ZTE CORPORATION**Product Change Description**

[Z999]

[Project Number:17ZTE191-01]

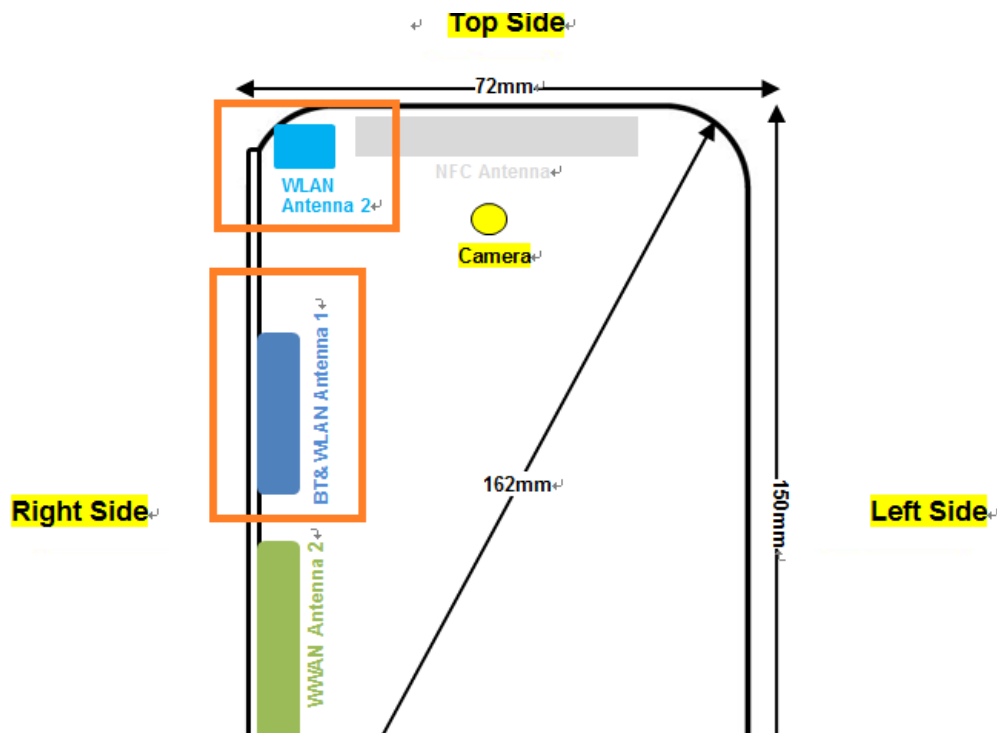
Other changes detailed: Yes, ZTE now switch WLAN Antenna 1 and 2's function. This means WLAN Antenna 2 in below picture now support Bluetooth and WIFI while WLAN antenna 1 only supports WIFI MIMO function.
